REMARKS/ARGUMENTS

Description of amendments

Figure – 10f

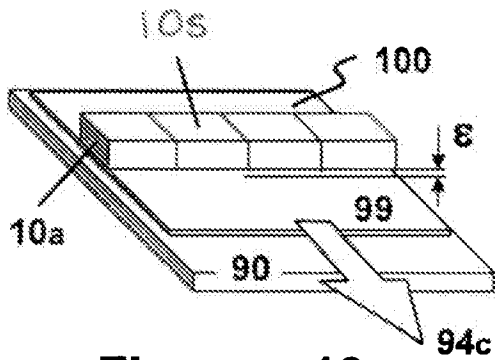
The drawings were objected to as failing to comply with 37CFR 1.84(p)(5). Specifically, the Examiner stated that reference numerals 18b, 12b, and 10s were not shown in the drawings.

Applicants amended the drawings to overcome the Examiner's objections. Reference numeral 10s was accidentally omitted from Fig. 10f. Applicants have added to Fig. 10f the reference numeral 10s. Figs. 12a-d were amended by adding the legend "Prior Art."

With respect to reference numeral 10s, Applicants have amended Figure 10f to add the reference numeral.

Figure - 12a (Prior art)

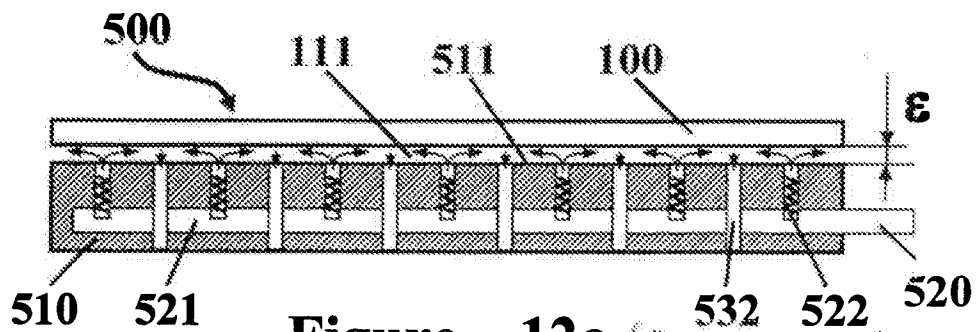
The Examiner also stated that Figures 12a-12d should be designated as prior art. Applicants have amended the figures as suggested by the Examiner.
